PARTS & SERVICE NEWS

REF NO.	AA00063
DATE	May 8, 2000

SUBJECT: CHANGE IN POSITION LIMIT SWITCH.

Figure 1. Typical Bucket Switch Mounting (WA120-3L and WA180-3L)

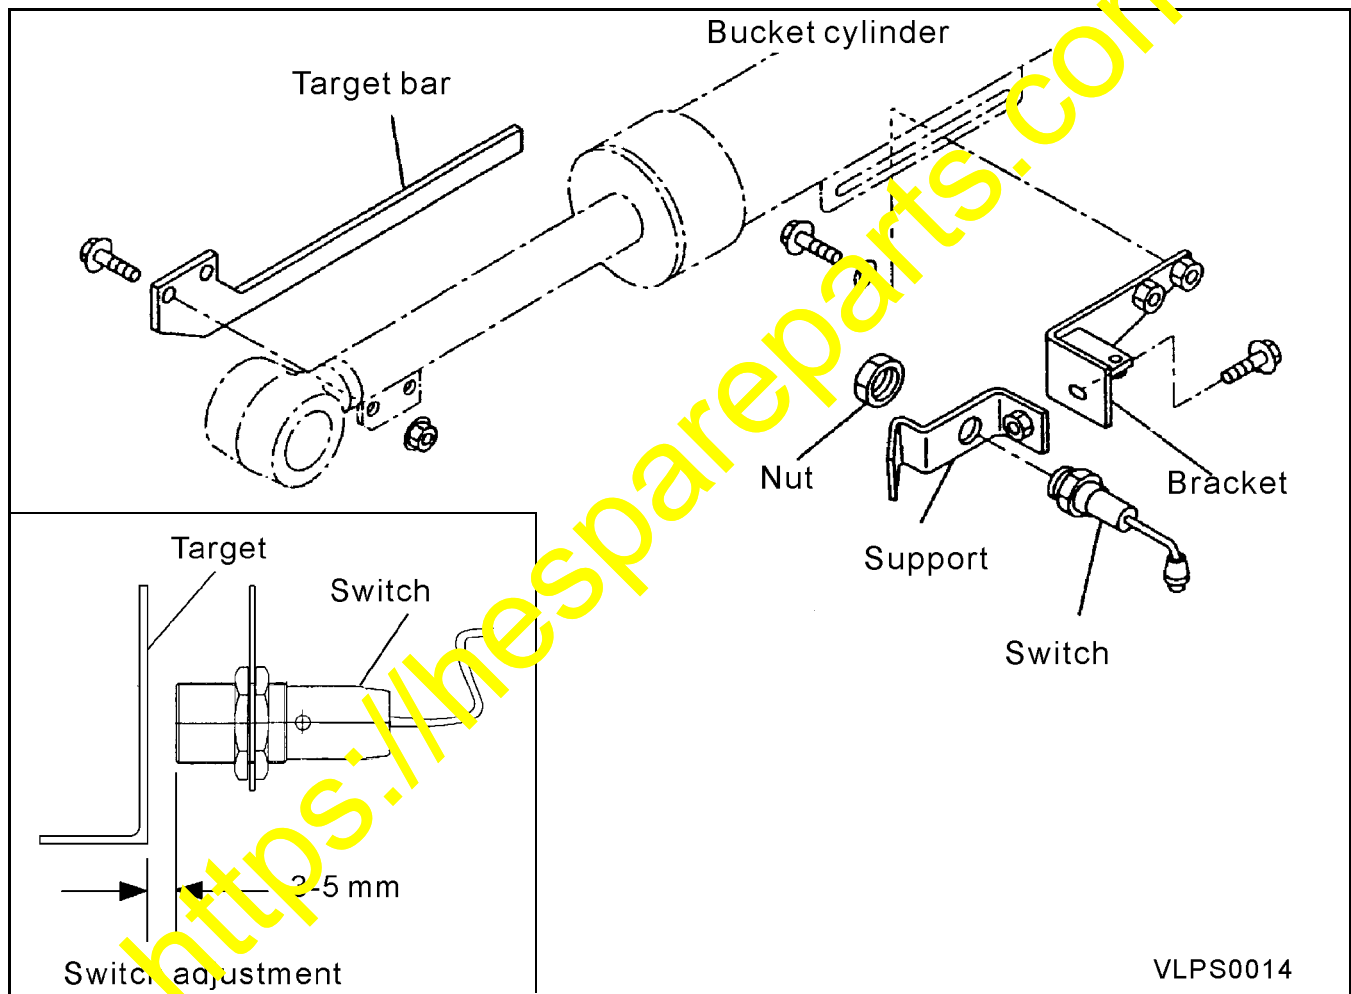
2. Obtain correct replacements (part number 363-06-321121) for the two switches, and remove the old switches from the equipment. Typical installations are shown in the illustrations. Make note of mechanical and electrical connections for later reassembly.

3. Install the new switches, and connect them to the electrical system.
4. Measure the distance between the switch's face and its target. Clearance should be 3 to 5 mm. If necessary, loosen the mounting nuts and adjust switch position for clearance of 3 mm to 5 mm between the switch and the target. Tighten the nuts to 6.7 Nm (4.9 lbf-ft) torque.
